SERVICE No. 518 LETTER

Piper Aircraft Corporation

Modification of Exhaust Mufflers

PA-24-260 Comanches

Affected Muffler Assemblies

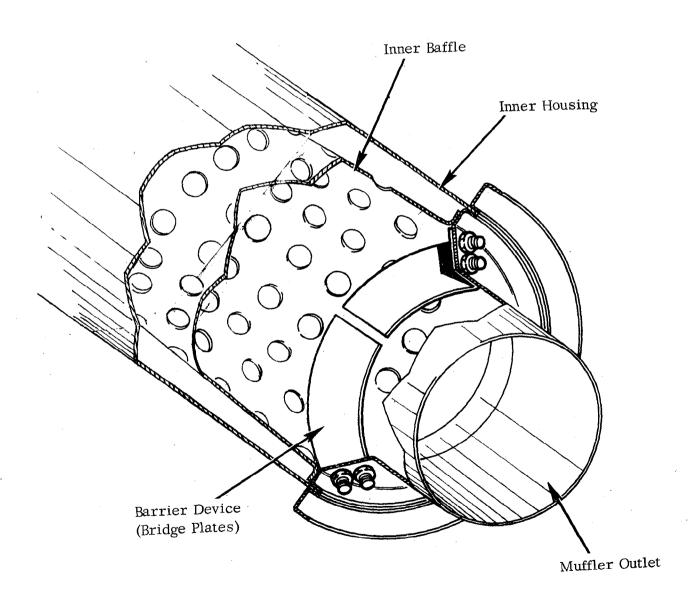
To provide materials and instructions for installation of a barrier device on the inside of each muffler (see sketch attached to this letter for additional information).

The subject modification, in conjunction with an adequate exhaust system inspection program (see paragraph below), will minimize the possibility of engine exhaust restriction with resulting power reduction, in the event deterioration of the muffler inner baffle should occur.

New replacement exhaust mufflers which incorporate the barrier devices (contained in Kit No. 760 289) will have new part numbers assigned, as follows:

Non-modified exhaust mufflers part numbers 24863-00, -04, 26345-02 and -03 must not be installed in aircraft following receipt of this letter.
